FEBRUARY 24TH, 2022

PRODUCT UPDATE

NEW BOARD FOR CI PRODUCTION

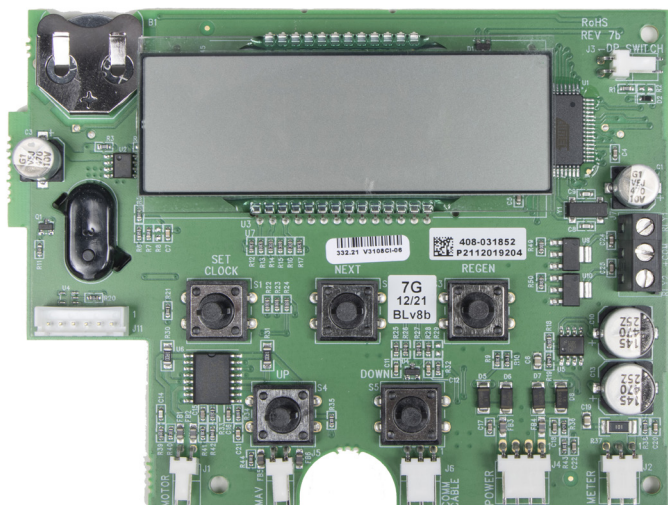
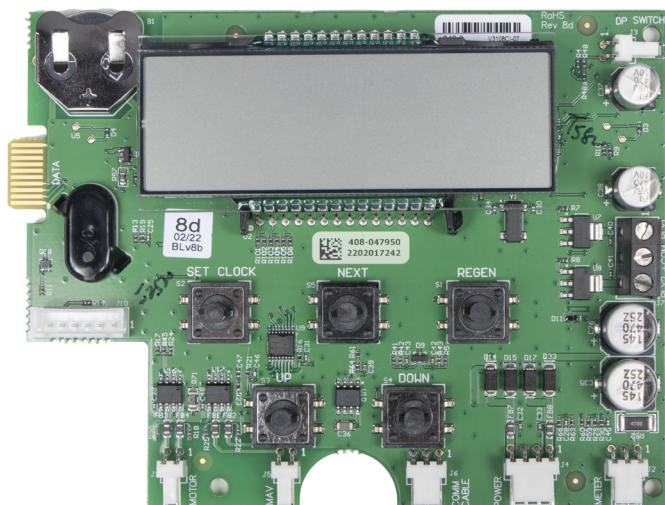
- Due to supply chain availability, we have sourced available component parts to support valve production and replacement board needs.
- The CI-07 board features new edge card connection for programming valve configurations.
- The CI-07 will require you to create **New Configuration Files** for use with the Clack Configurator.
- The CI-07 offers a **NEW FEATURE** of simple Progressive Flow in programming up to 4 units without using the System Controller.
- We will use both CI-06 and CI-07 as we continue to dual source, please note you may receive shipments with a mixture of both CI-06 and CI-07 boards.
